Re: Request for Four Route and Corridor Changes
Northern States Power Company
Fargo-St. Cloud MN 345 kV CapX Transmission Line Siting Application
Case No. PU-07-759

156 PU-07-759 Filed 07/01/2013 Pages: 19
Application for 4 route and corridor changes
Northern States Power Company
Thomas G. Hillstrom

Fargo to St. Cloud 345 kV Transmission Line Project Reroute 1 (Maple River)

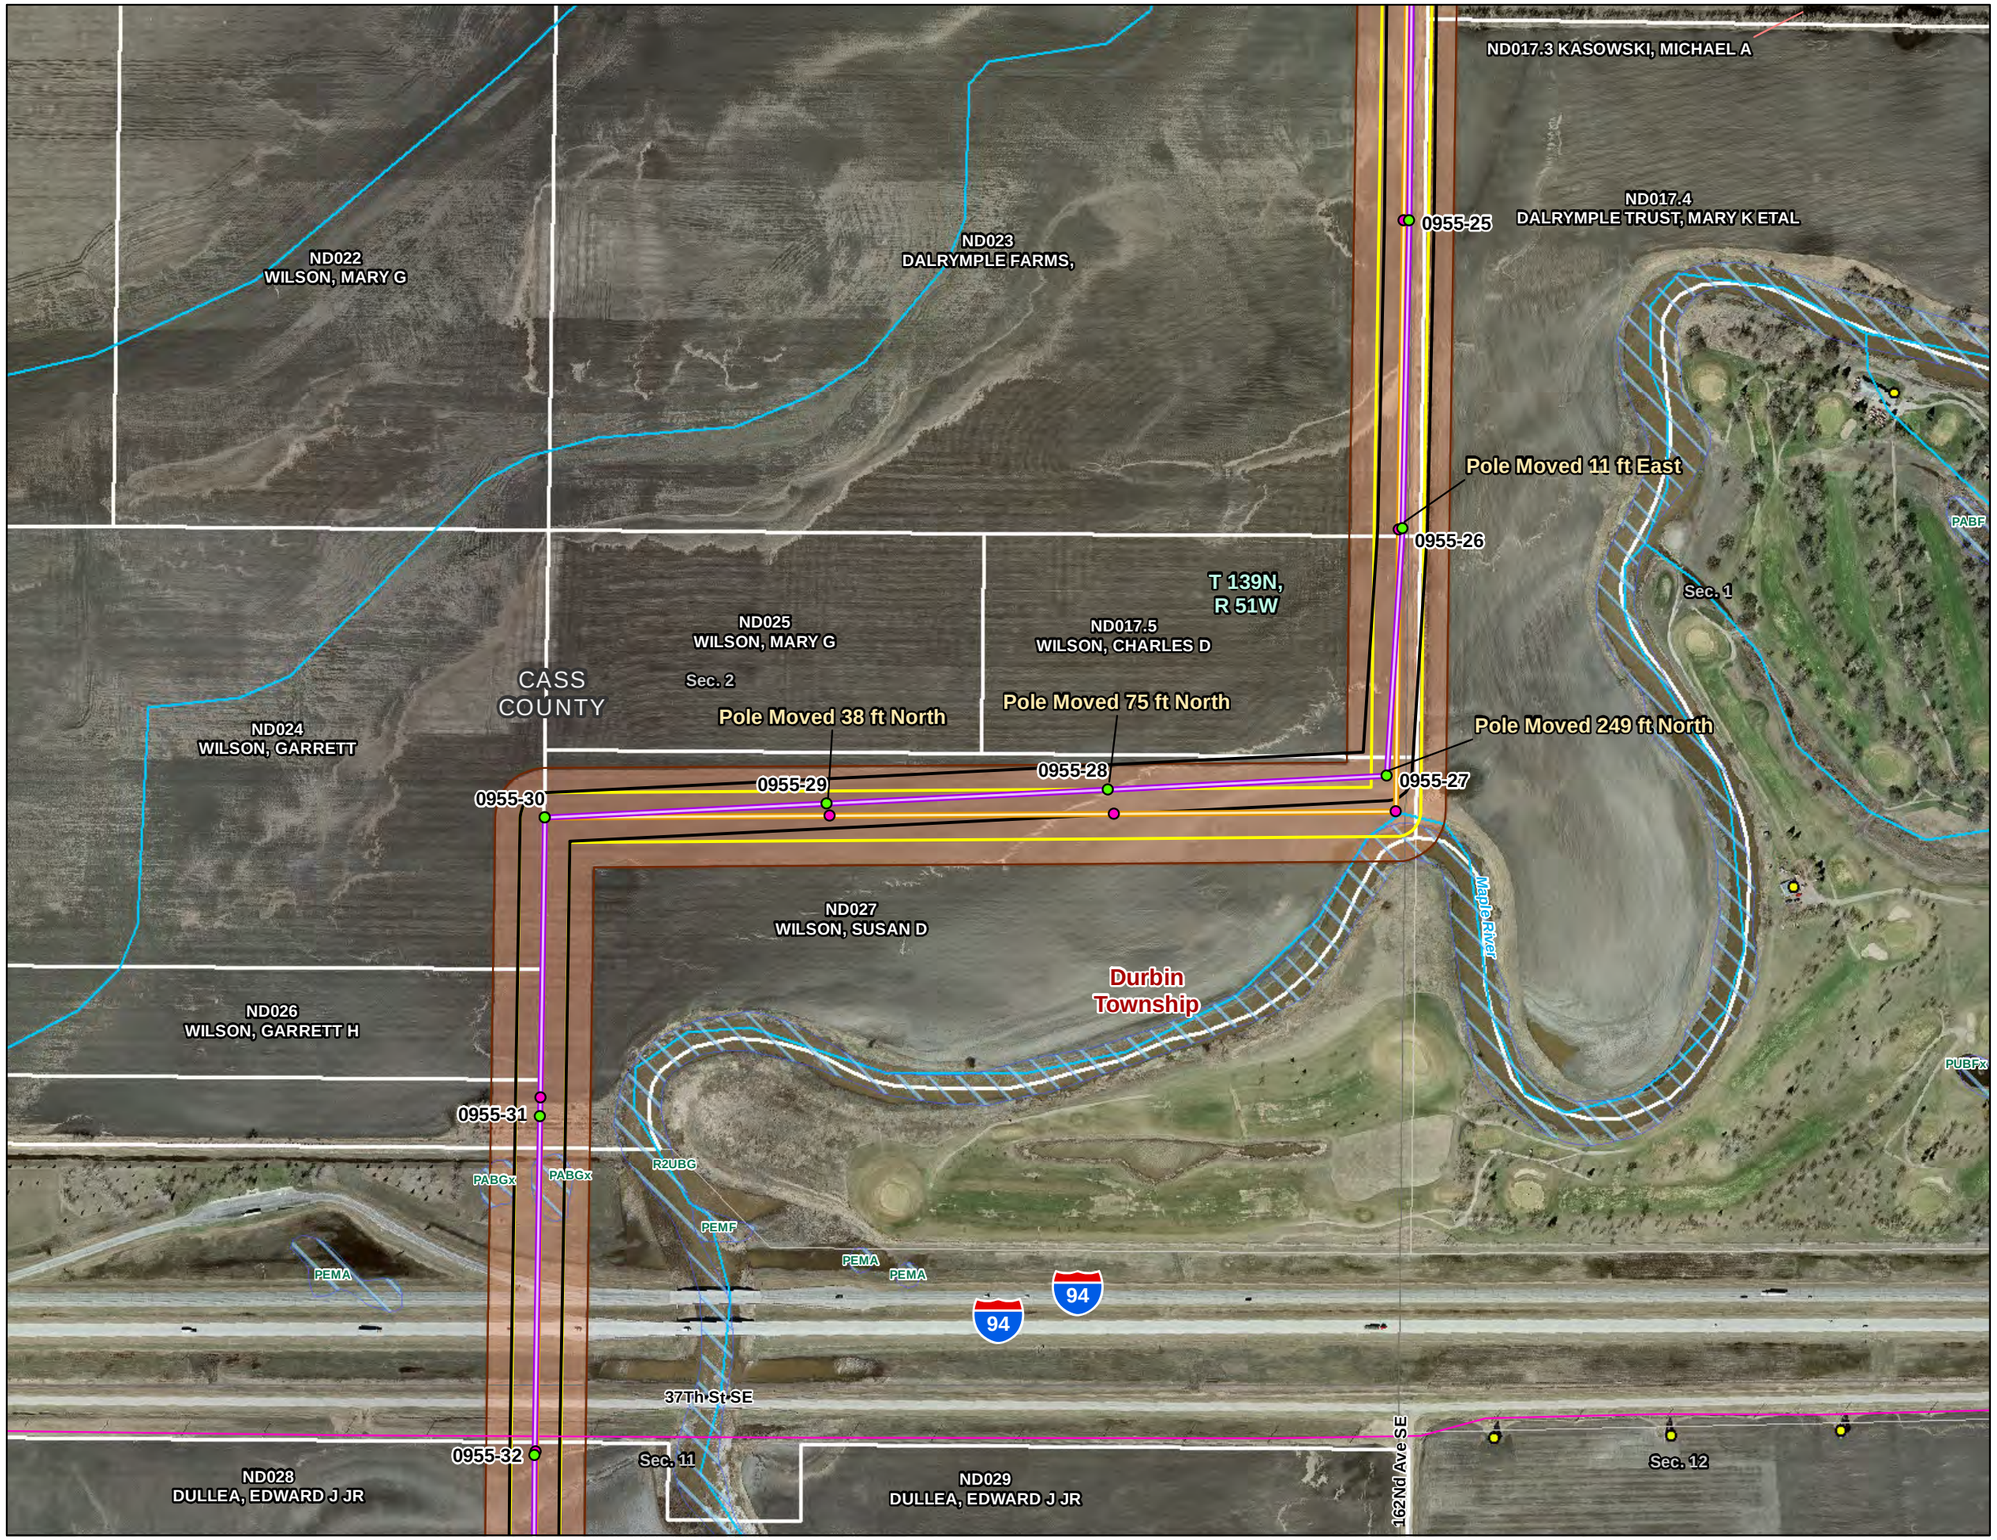
Change 1: Change one in Durbin Township is a design modification to relocate two poles farther from the Maple River. To accommodate this change, poles 29, 28 and 27 would be moved approximately 38, 75 and 249 feet north, respectively, resulting in a route shift and a slight expansion of the corridor. All three poles remain in the approved corridor but some right-of-way is outside the corridor. The two affected landowners support this adjustment.

Fargo to St. Cloud 345 kV Transmission Line Project Reroute 2 (Gust Property)

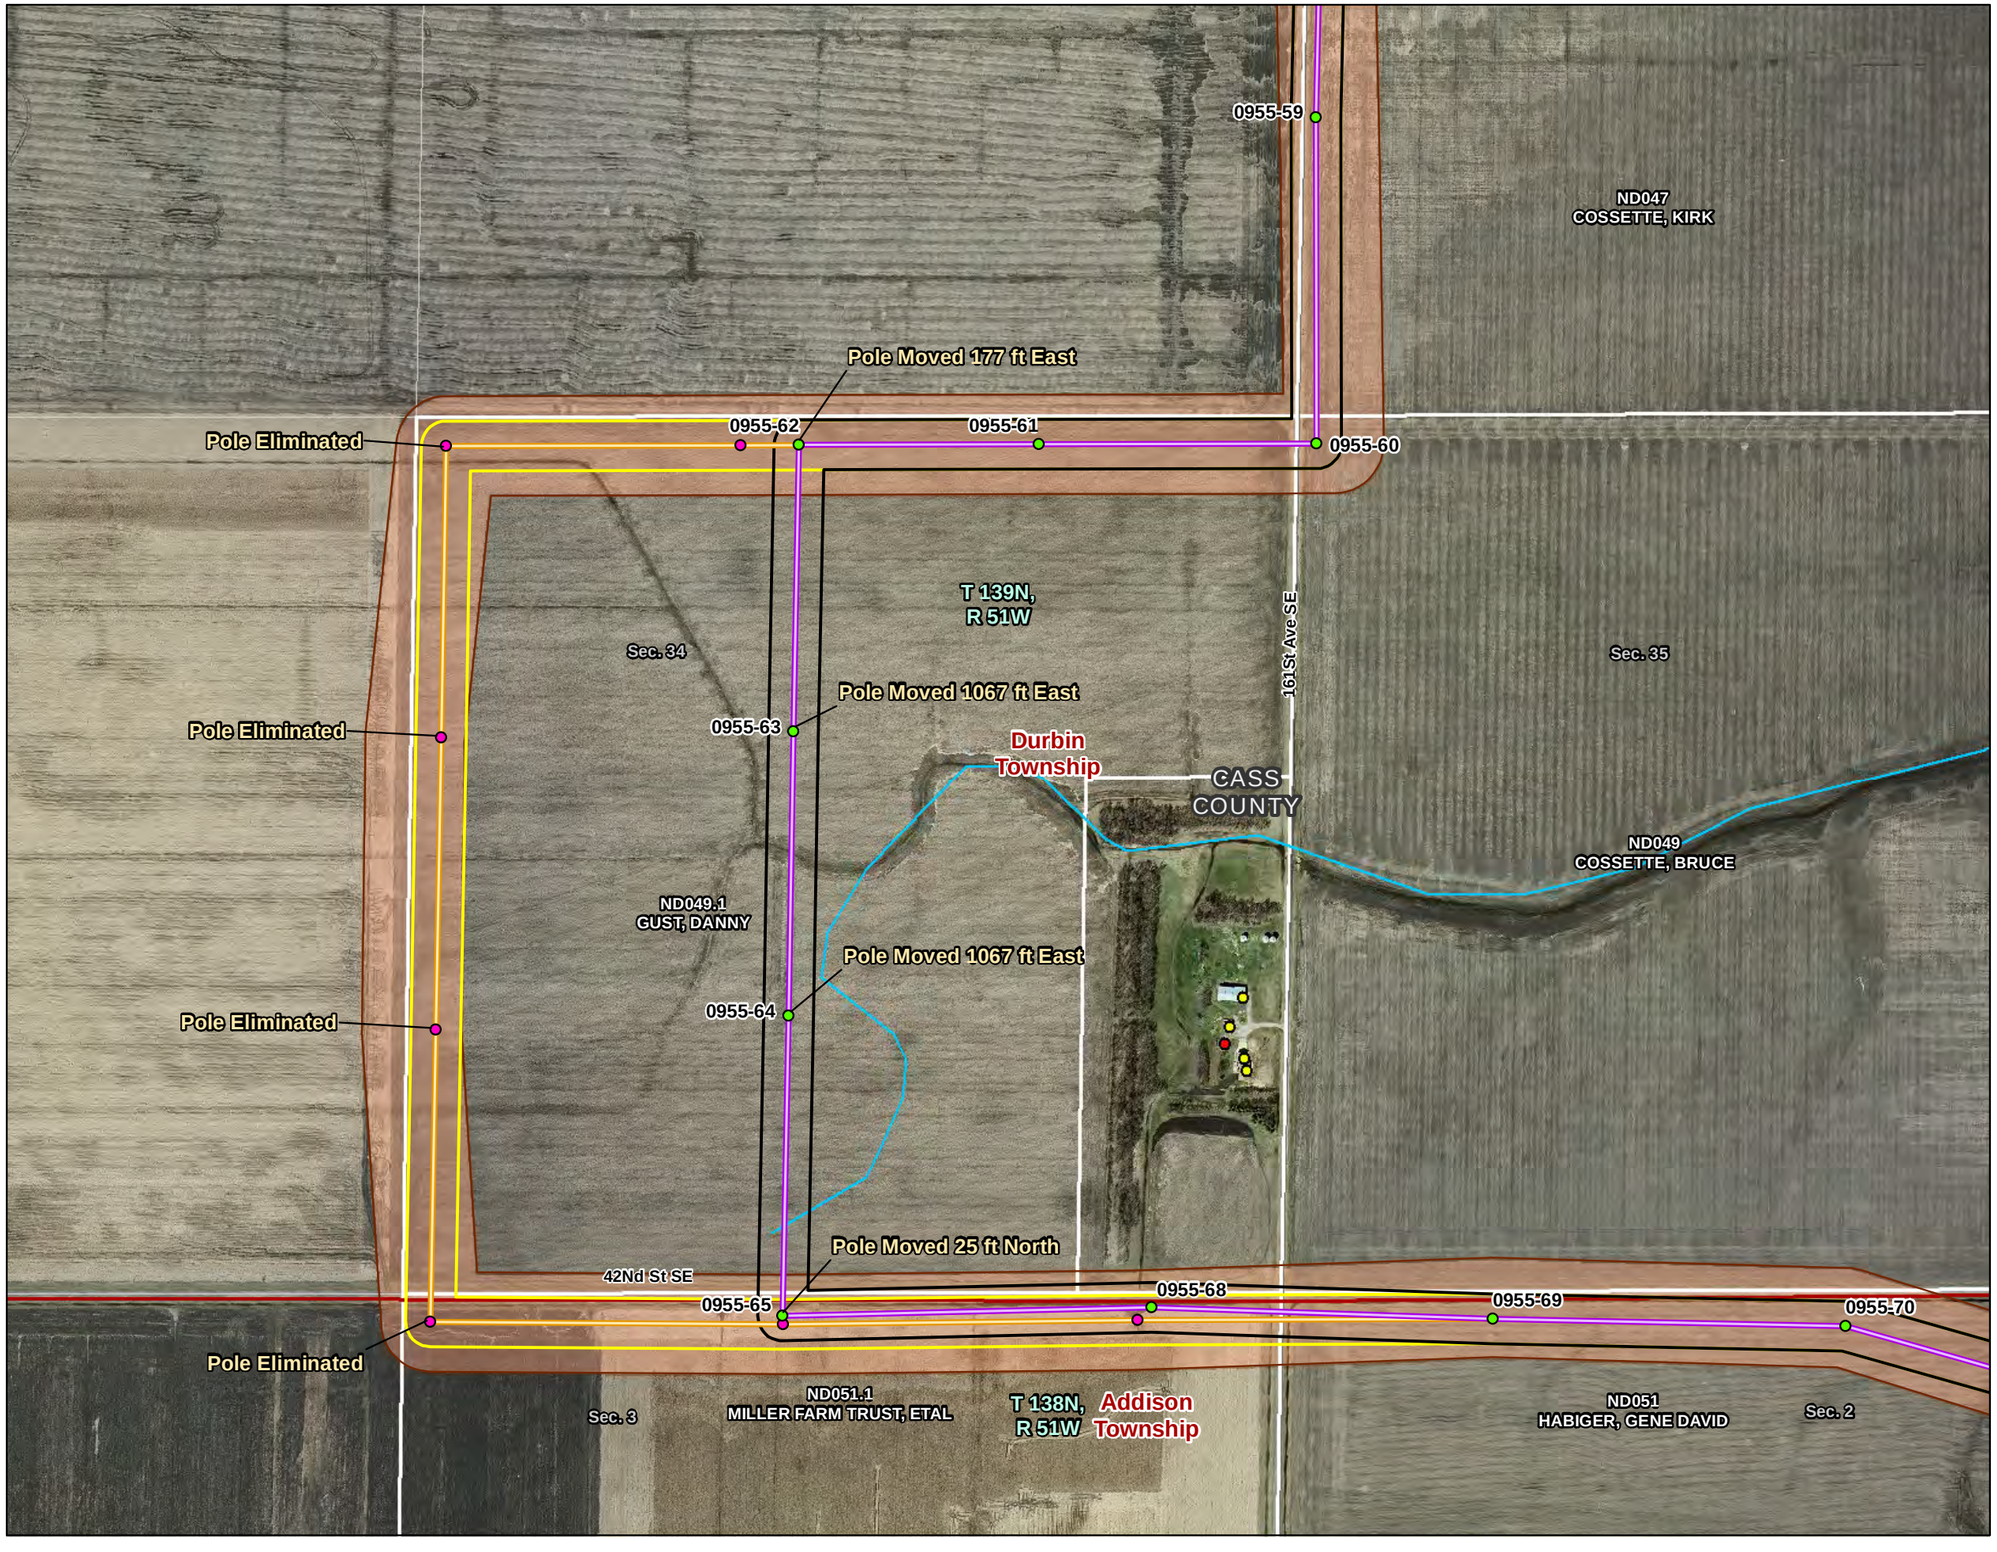
Change 2: Change two in Durbin and Addison townships was requested by the landowner to better accommodate property ownership lines after an inheritance where the land was split into two parcels. The modified alignment keeps the line on one of the two parcels. This change involves elimination of two poles and a shift in pole location from the section line, 1,067 feet to the east.

Fargo to St. Cloud 345 kV Transmission Line Project Reroute 3 (Hoyme Property)

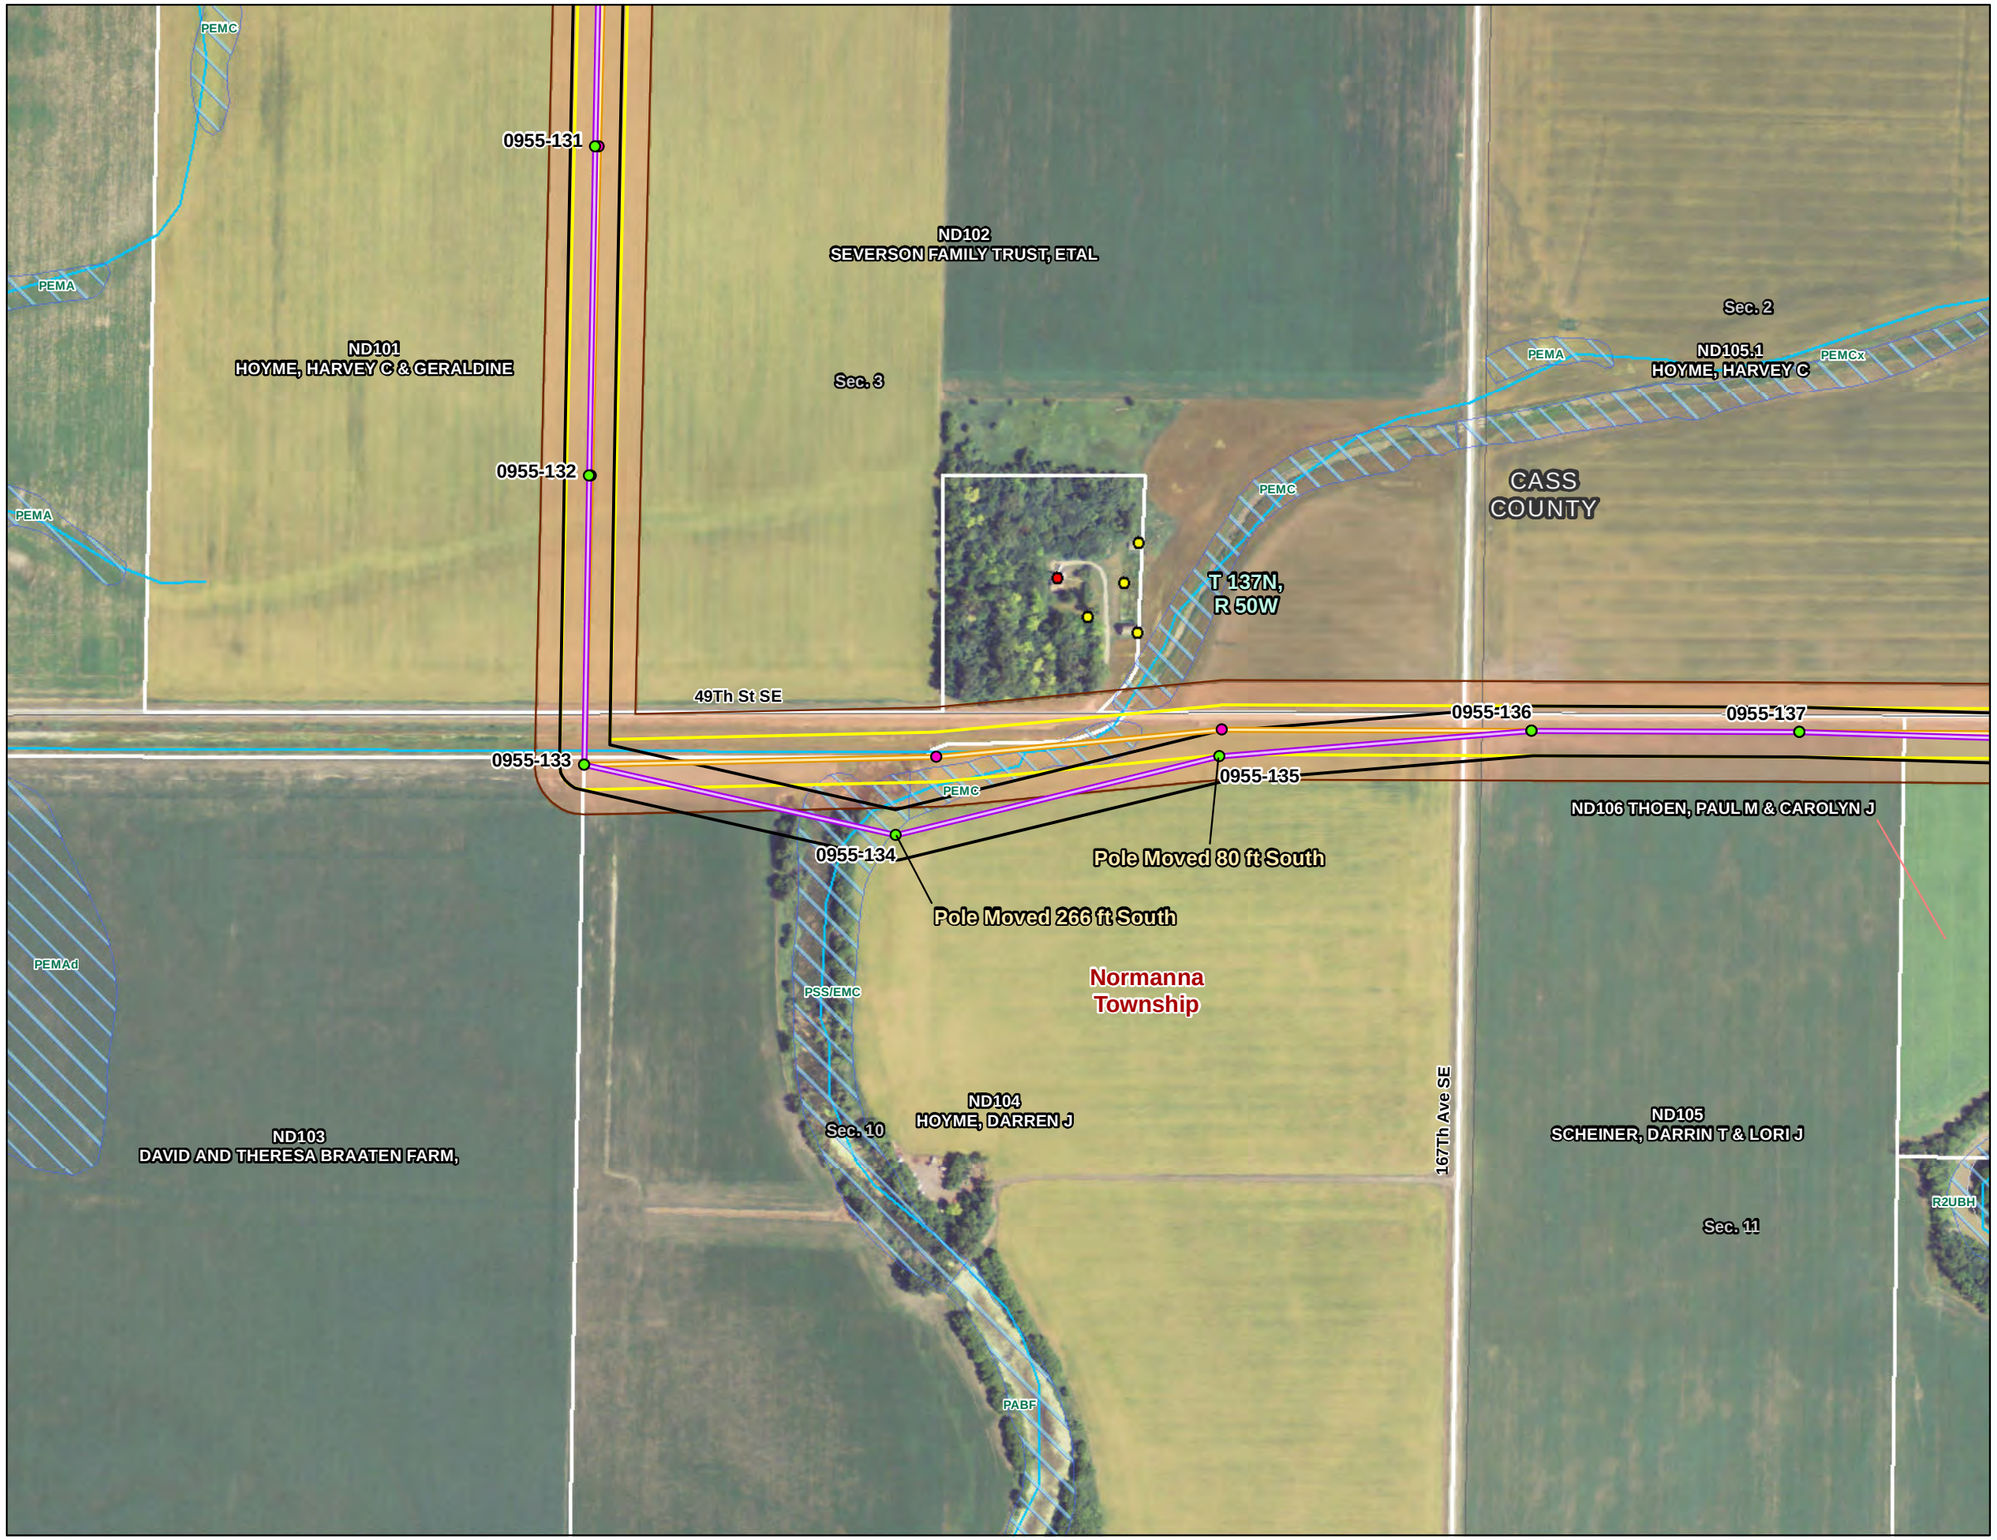
Change 3: Change three in Normanna Township was requested by the landowner and the CE Cass Water Resource District to facilitate maintenance of the ditch. The ditch is necessary to manage runoff on the landowner's property. The change moves two poles, 134 and 135, 80 and 266 feet south, respectively.
